**Appendix 11**

**Summary of Traffic Survey Data, Queue Length Data and  
Junction Geometry Drawings**

**Previous Planning Consultation Comments and  
Response Documents**

# Response to WSCC Strategic Planning Consultation Comments dated 6 September 2012

**2011 Observed Queue Lengths  
AM Peak Hour**

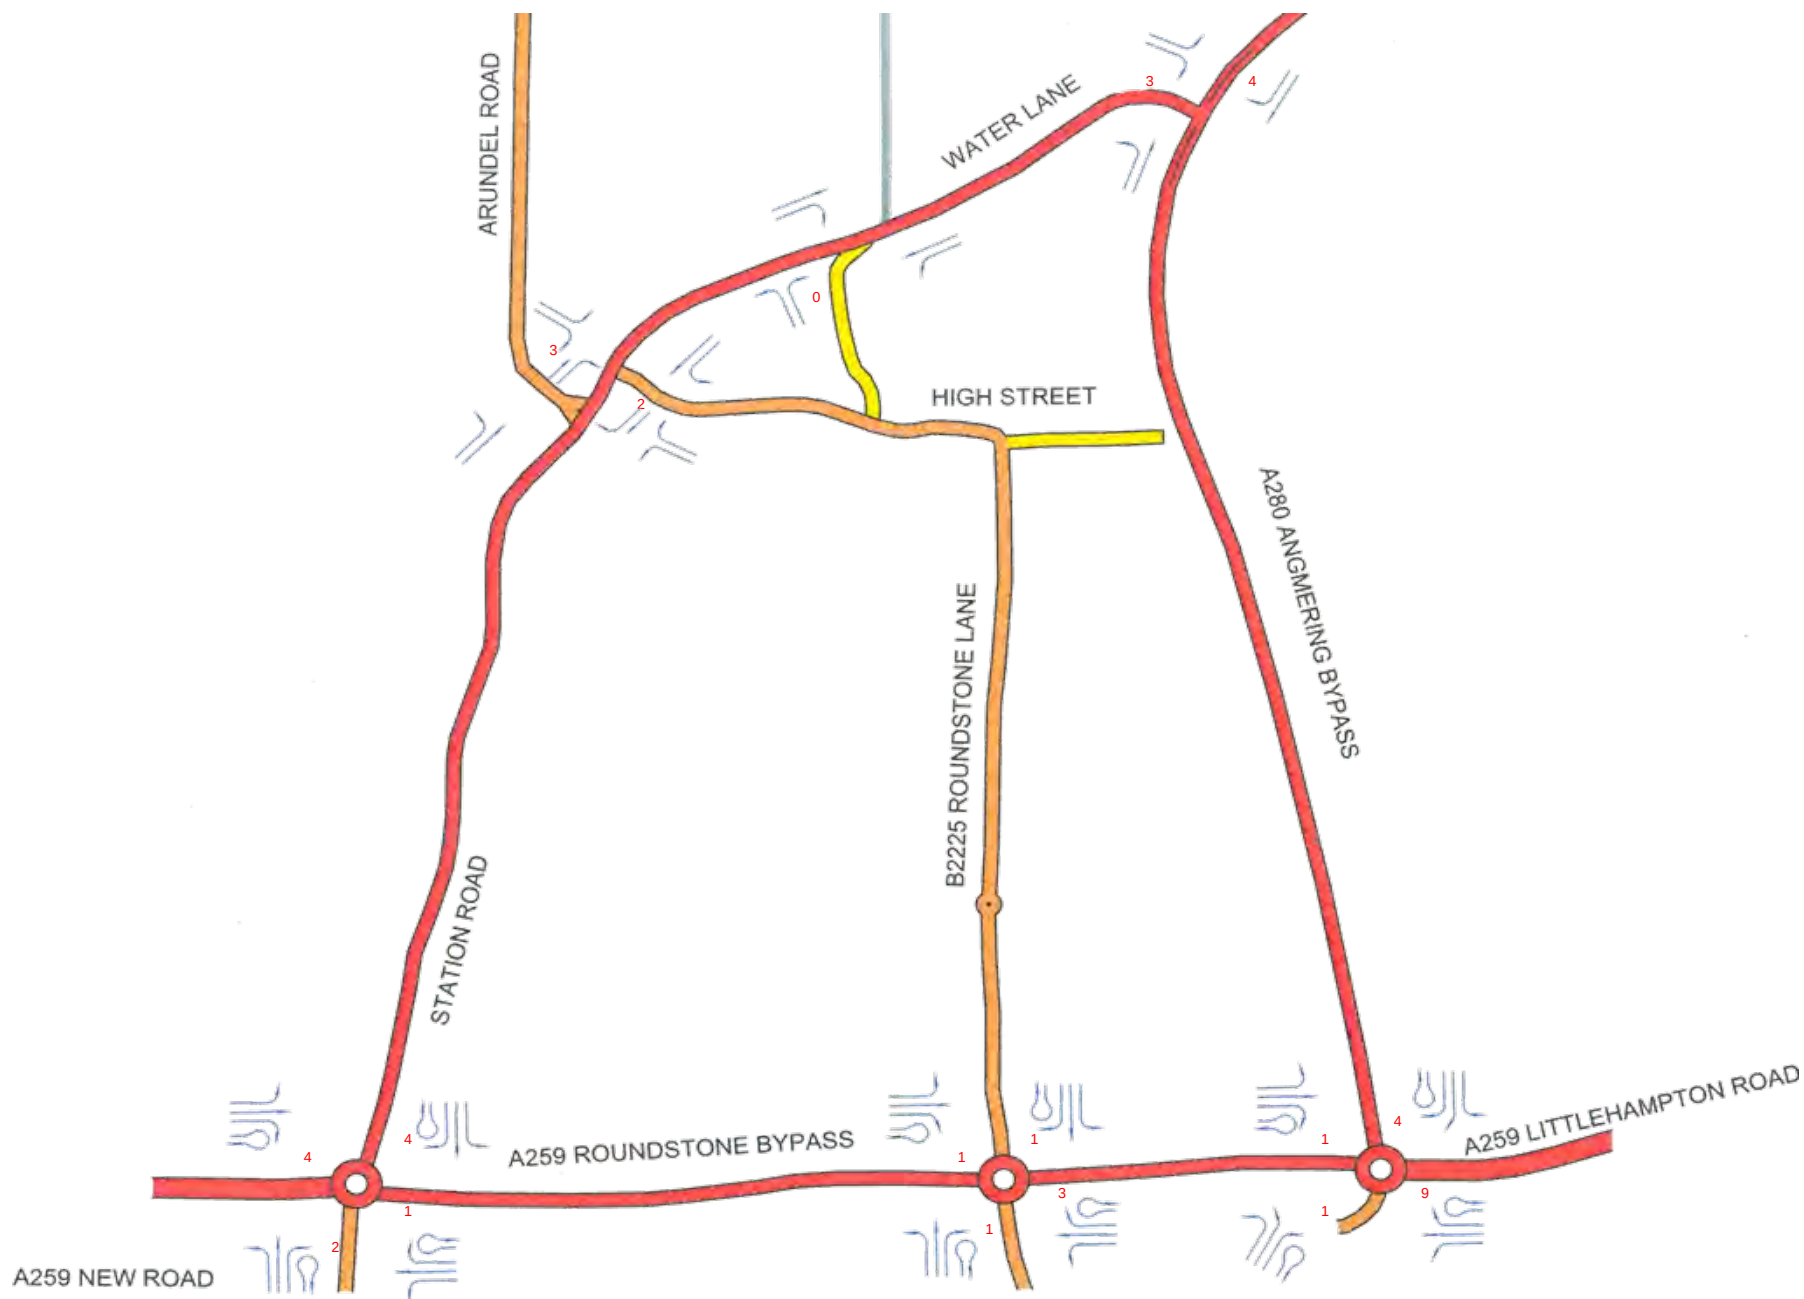
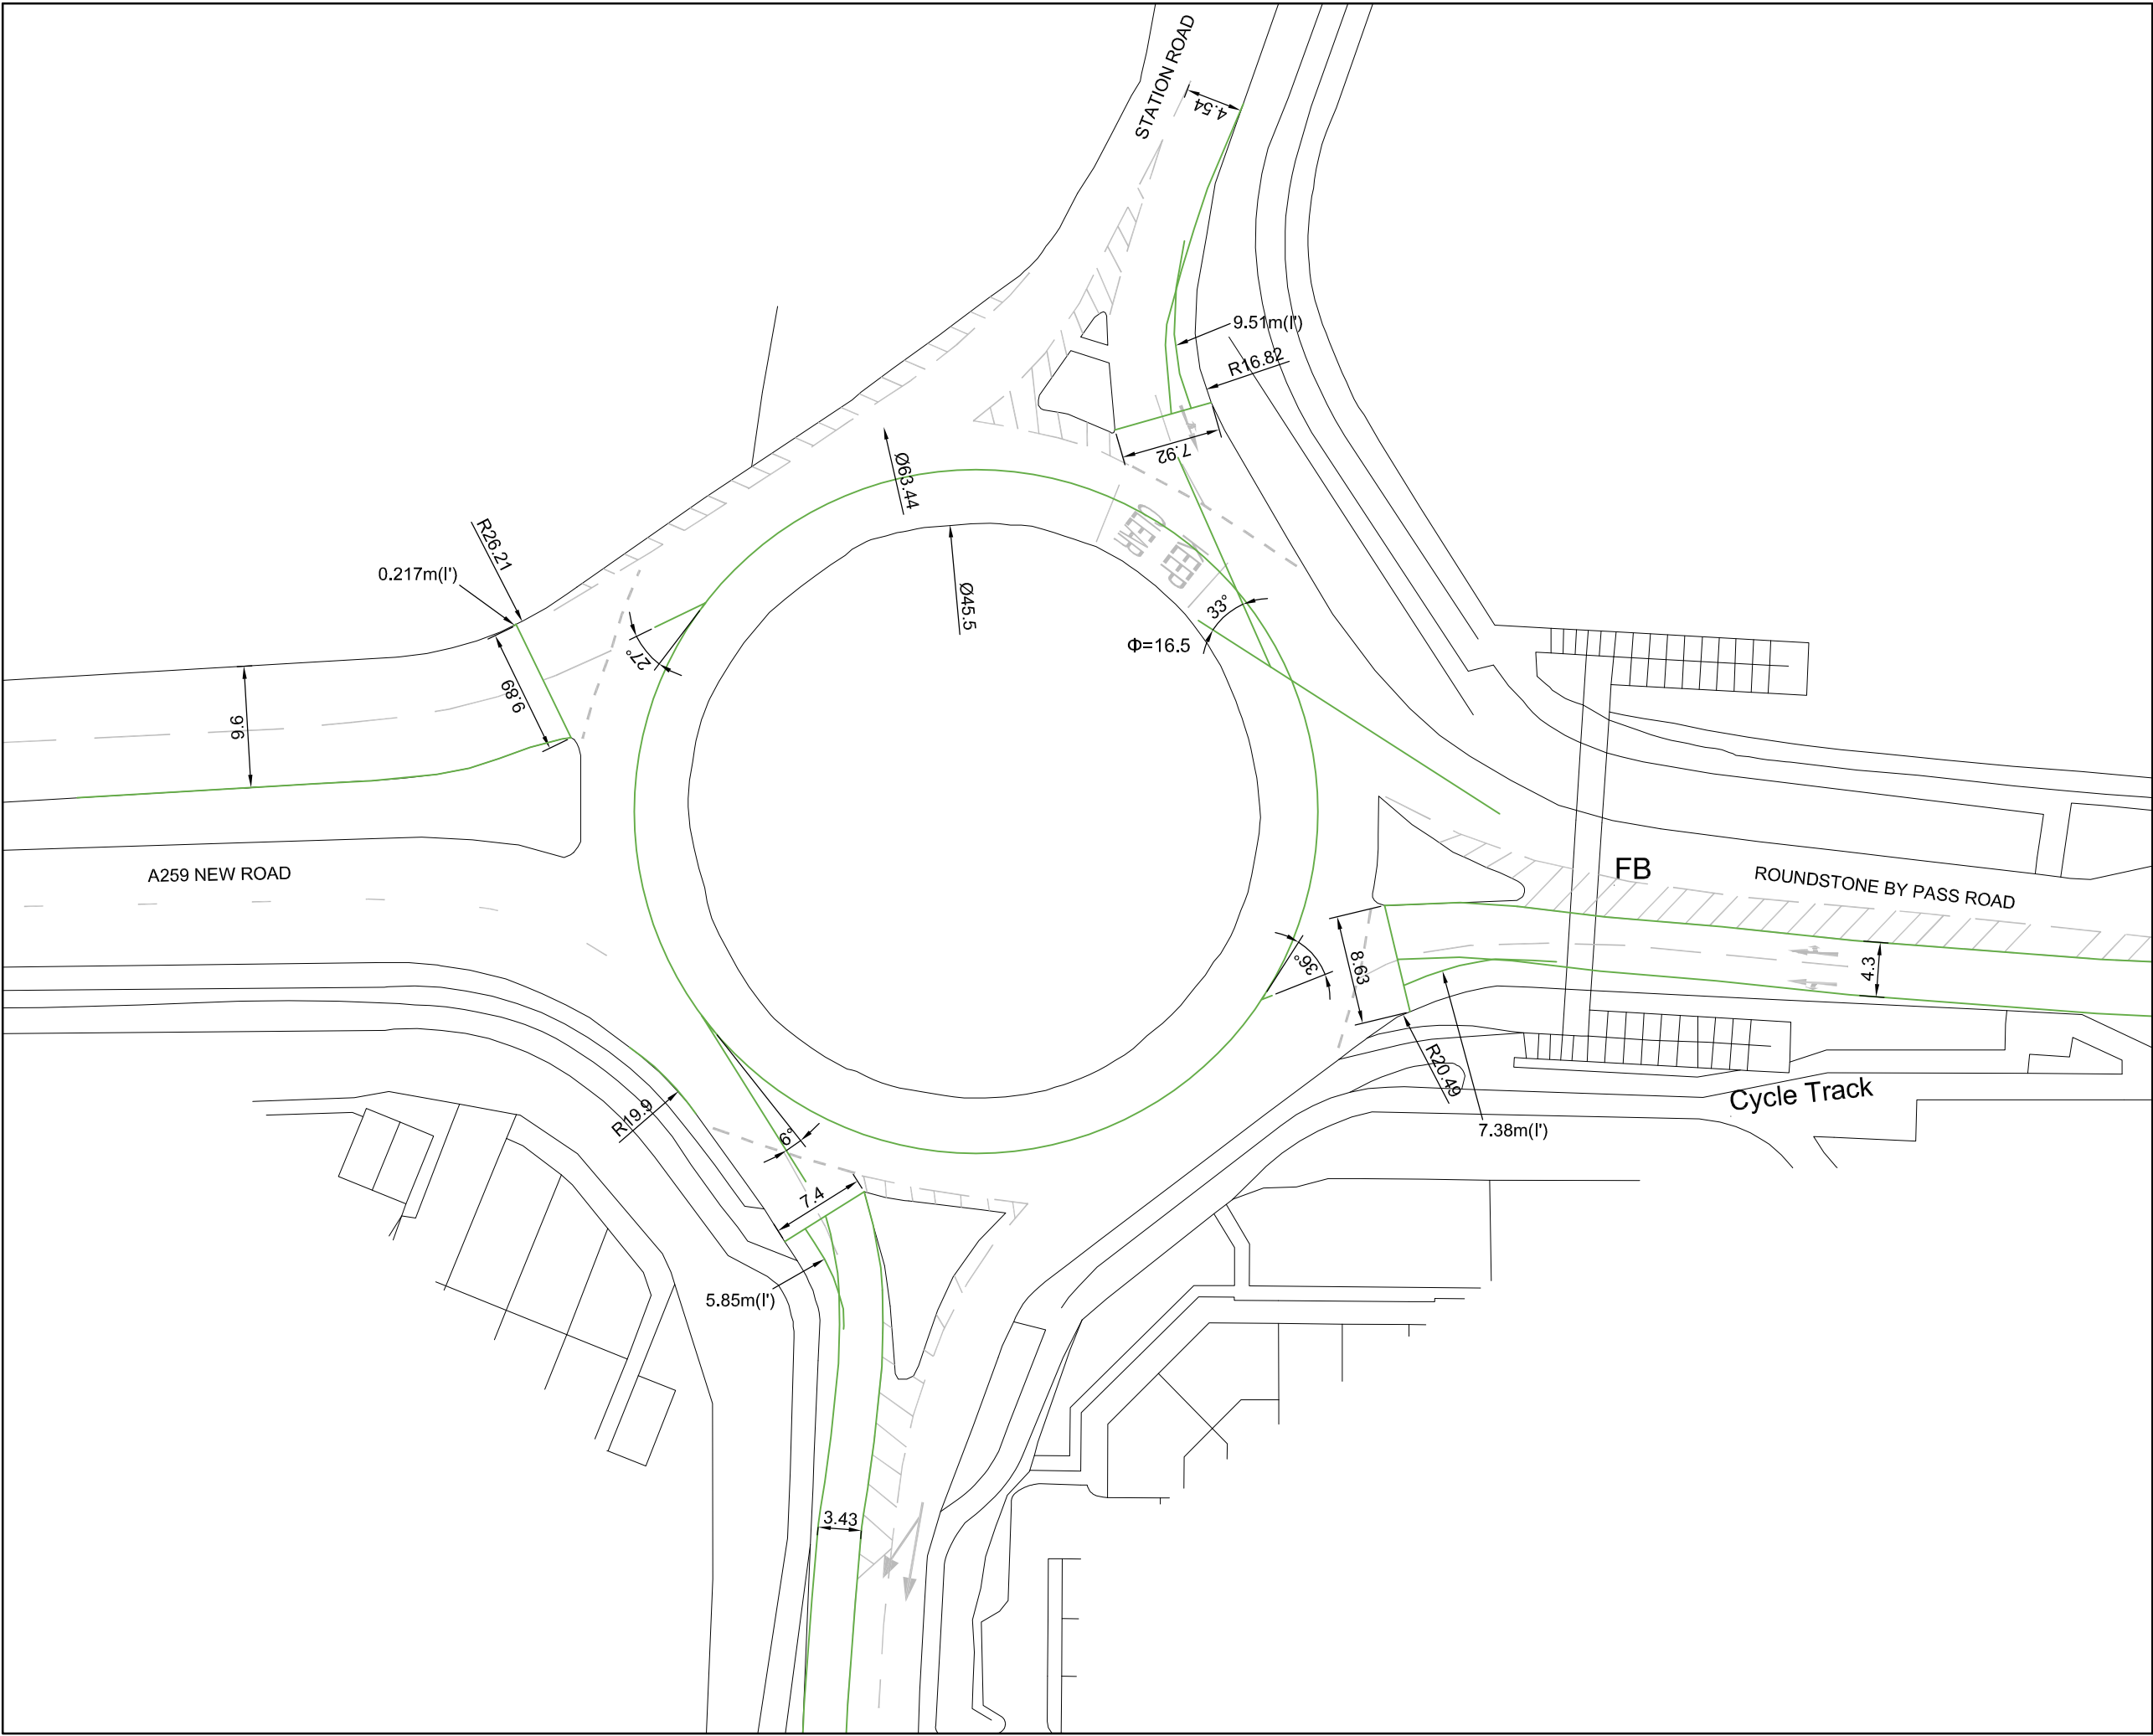
Junction assessments: These do not appear to be consistent with observed traffic conditions on the A259 or at Water Lane/A283. The queue lengths in Appendix 11 appear to be lower than actual observed queue lengths during the morning and evening peak hours. Further detail should be provided on the junction assessments relating to the A259 to explain the relationship between observed congestion and the technical junction assessments. The A283 Angmering Bypass/Water Lane junction is also subject to congestion with traffic queuing (for example) from the traffic calming build-outs on Water Lane to the junction, causing the right-turn lane on the A283 to exceed capacity.

*'Junction assessments: These do not appear to be consistent with observed traffic conditions on the A259 or at Water Lane/A283. The queue lengths in Appendix 11 appear to be lower than actual observed queue lengths during the morning and evening peak hours. Further detail should be provided on the junction assessments relating to the A259 to explain the relationship between observed congestion and the technical junction assessments.'*

We had not observed this scenario on the A280 having visited site several times during peak times and the queue lengths recorded in the traffic survey do not show this situation occurring but are aware the priority traffic calming on Water Lane causes a significant restriction and this may affect the ability of traffic on the A280 to enter Water Lane which would in turn affect route choice.

To clarify any confusion about the observed queue lengths provided in Appendix 1 of our previous note dated 30 November the numbers shown in red on the schematic diagrams titled Observed Queue Lengths are the average recorded queue lengths shown on each arm taken from the recorded queue lengths provided by the traffic survey company. The raw data was supplied and appended with the schematic diagrams from which the corresponding numbers can be seen.
